SUBJECT: PUBLIC MEETING TO DISCUSS COMMENTS BY THE
NUCLEAR ENERGY INSTITUTE REGARDING THE
INTERNATIONAL NUCLEAR EVENT SCALE

SUBJECT: NEI International Nuclear Event Scale Recommendations May 2003

Nuclear Energy Institute
International Event Scale Meeting
June 25, 2003

International Nuclear Event Scale (INES) Meeting

PWR Typical Technical Specification Activity Example Curve

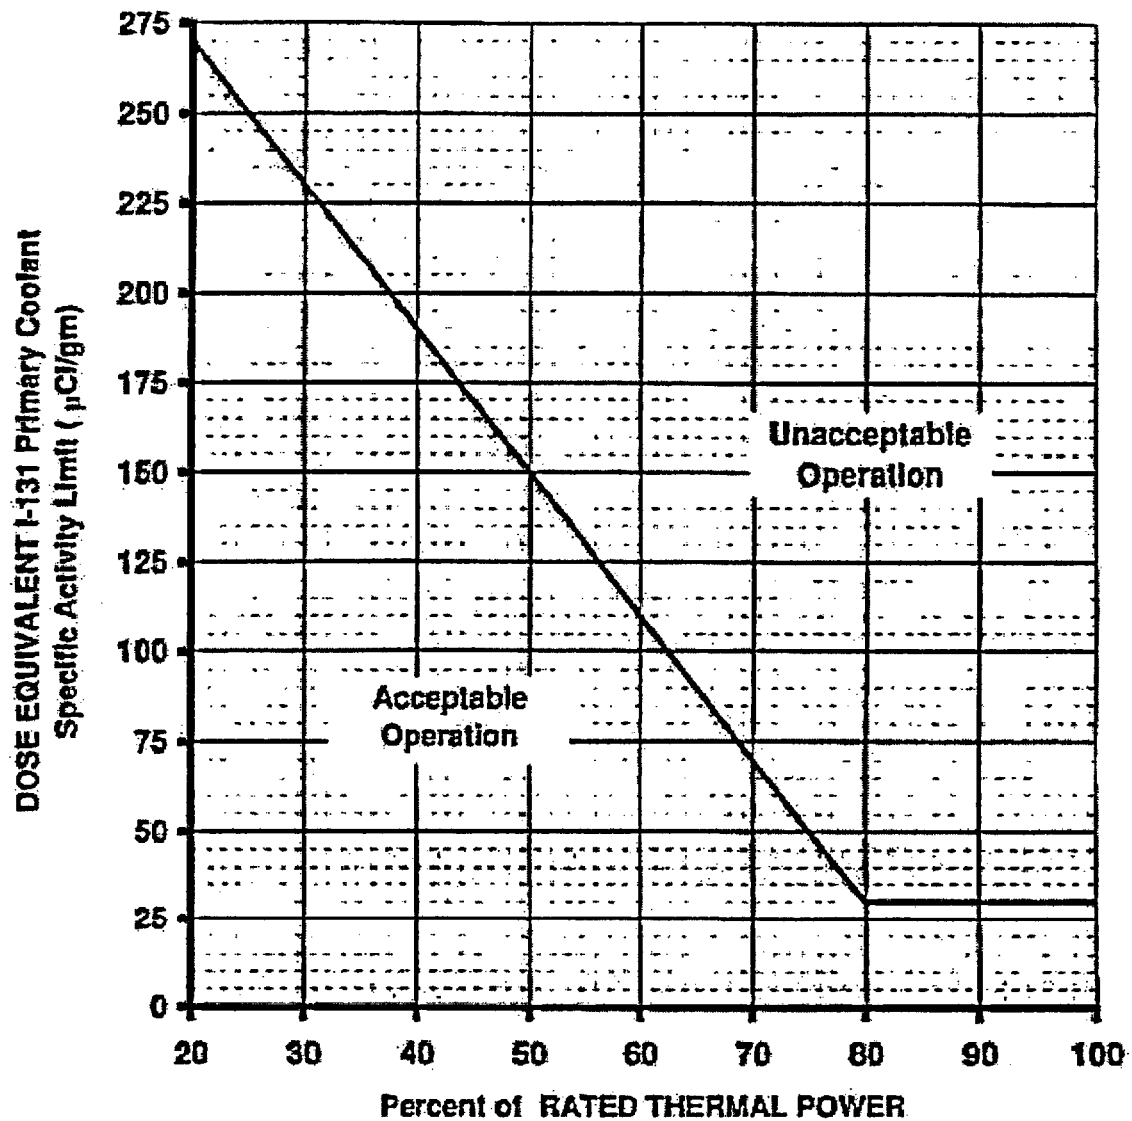
4) Defense In Depth Level 2 Clarification

Recommended Example Addition:

DEI or E-bar elevated out of normal operating limits requiring shutdown

5) Defense in Depth Level 1 Clarification

Recommended Example Addition:

DEI or E-bar elevated out of normal operating limits but returned to within normal operating limits within specified action statement time limits

6) Defense in Depth Level 0 Clarification

Recommended Example Addition:

DEI or E-bar elevated but within normal operating limits - no Mandatory LCO exists

Change Justification:

Example is consistent with current Defense-In Depth approach. If Level 2 criteria is met then the event is most likely not due to just an Iodine spike therefore indicating potential clad failure. Level 2 classification is therefore appropriate. This definition is consistent with the Emergency Action Level (EAL) classification methodology of NEI 99-01, Revision 4, for a Notification of Unusual Event based on a Technical Specification required shutdown. Escalation to level 4 would occur should reactor coolant activity exceed $300 \mu\text{C/cc DEI}$.

Change Justification:

Example is consistent with current Defense-In Depth approach. If Level 1 criteria is met then the event is most likely due to an iodine spike and not an indication of potential clad failure. Level 1 classification is therefore appropriate. This example would not result in the Emergency Action Level (EAL) classification methodology of NEI 99-01, Revision 4, being exceeded and would therefore not result in an emergency classification. Technical Specifications would require Notifications and documentation of the event per the LER process. Escalation to level 2 would occur should reactor coolant activity not return to within normal operating limits within specified action statement time limits.

Change Justification:

Example is consistent with current Defense-In Depth approach. If Level 0 criteria is met then the plant is operating within normal licensed parameters and safety risk exists. Level 0 classification is therefore appropriate. This example would not result in the Emergency Action Level (EAL) classification methodology of NEI 99-01, Revision 4, being exceeded and would therefore not result in an emergency classification. Escalation to level 1 would occur should reactor coolant activity increase above normal operating limits.

PWR Typical Technical Specification Activity Example Curve

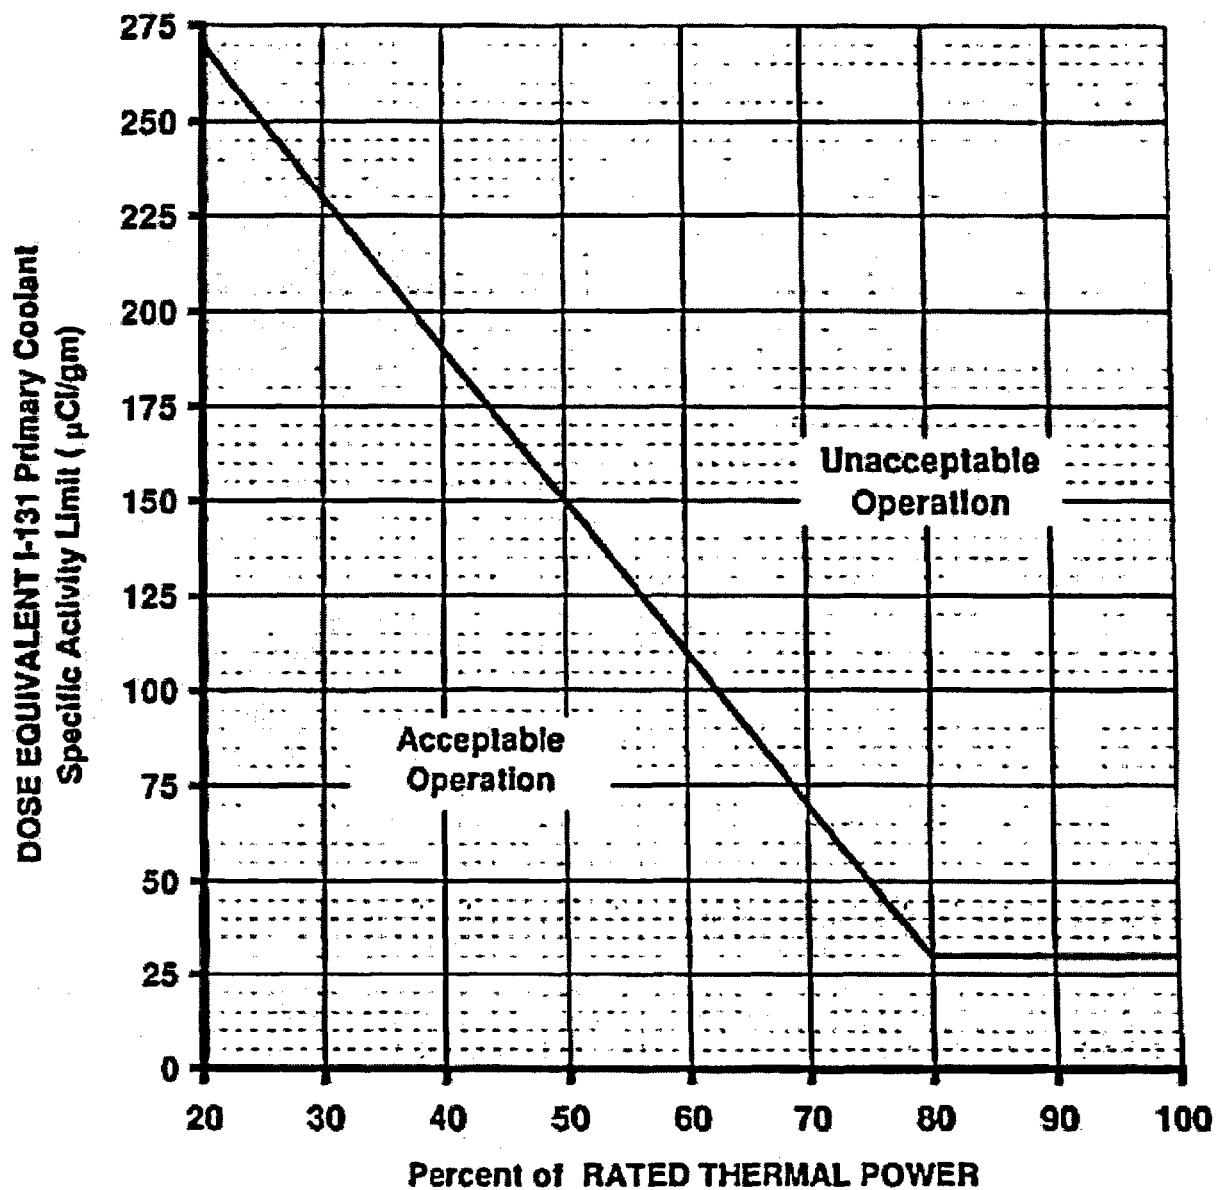
4) Defense In Depth Level 2 Clarification

Recommended Example Addition:

DEI elevated into the Unacceptable Operation region of the Technical Specification transient limit requiring shutdown.

5) Defense In Depth Level 1 Clarification

Recommended Example Addition:

DEI elevated into the Allowable Operation region of the Technical Specification transient limit for greater than the specified action statement time limit requiring shutdown.

6) Defense In Depth Level 0 Clarification

Recommended Example Addition:

DEI elevated out of normal Technical Specification operating limit but returned to within normal operating limit within specified action statement time limit with no shutdown required

Change Justification:

Example is consistent with current Defense-In Depth approach. If Level 2 criteria is met then the event is most likely not due to just an Iodine spike therefore indicating potential clad failure. Level 2 classification is therefore appropriate. This definition is consistent with the Emergency Action Level (EAL) classification methodology of NEI 99-01, Revision 4, for a Notification of Unusual Event based on a Technical Specification required shutdown. Escalation to level 3 would occur should reactor coolant activity exceed 300 $\mu\text{c/cc}$ DEI.

Change Justification:

Example is consistent with current Defense-In Depth approach. If Level 1 criteria is met then the event is most likely due to an Iodine spike and not an indication of potential clad failure. Level 1 classification is therefore appropriate. This example would probably not result in the Emergency Action Level (EAL) classification methodology of NEI 99-01, Revision 4, being exceeded since the plant would most likely be shutdown proactively prior to exceeding the action statement time limit. Technical Specifications would require notifications and documentation of the event per the LER process. Escalation to level 2 would occur should reactor coolant activity exceed the Allowable Operation region of the transient limit curve.

Change Justification:

Example is consistent with current Defense-In Depth approach. If Level 0 criteria is met then the plant is operating within normal licensed parameters and no safety risk exists. Level 0 classification is therefore appropriate. This example would not result in the Emergency Action Level (EAL) classification methodology of NEI 99-01, Revision 4, being exceeded and would therefore not result in an emergency classification. Escalation to level 1 would occur should reactor coolant activity increase above normal operating limits and not return within the allowable transient time limit.

This meeting introduced minor revisions to the Defense in Depth examples previously provided to NRC from NEI via letter dated May 29, 2003. The revised examples better categorize risk to the public based on current INES definitions and therefore facilitate better communication of event safety significance.

PWR Technical Specification Example

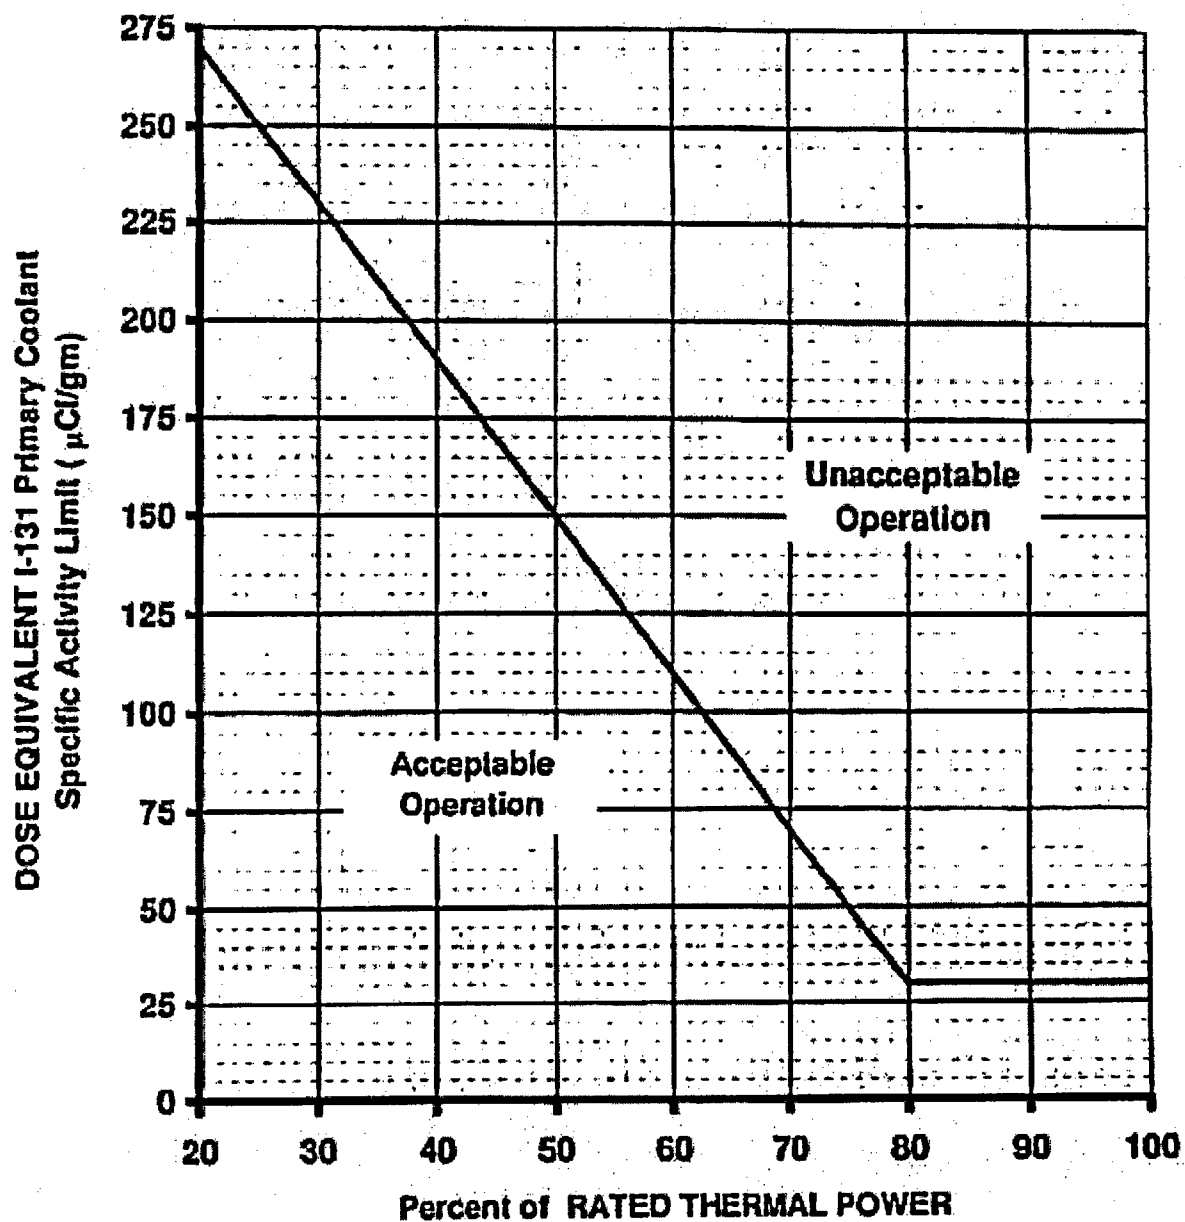
Defense in Depth Criteria

- Has multiple examples provided for the user but excludes examples dealing with RCS activity and clad damage
- Recommend RCS activity examples be added for clarification

Defense in Depth -Examples

- Level 2
 - ◆ DEI elevated into the Unacceptable Operation region of the Technical Specification transient limit requiring shutdown
- Level 1
 - ◆ DEI elevated into the Allowable Operation region of the Technical Specification transient limit for greater than the specified action statement time limit requiring shutdown
- Level 0
 - ◆ DEI elevated out of normal Technical Specification operating limit but returned to within normal operating limit within specified action statement time limit with no shutdown required
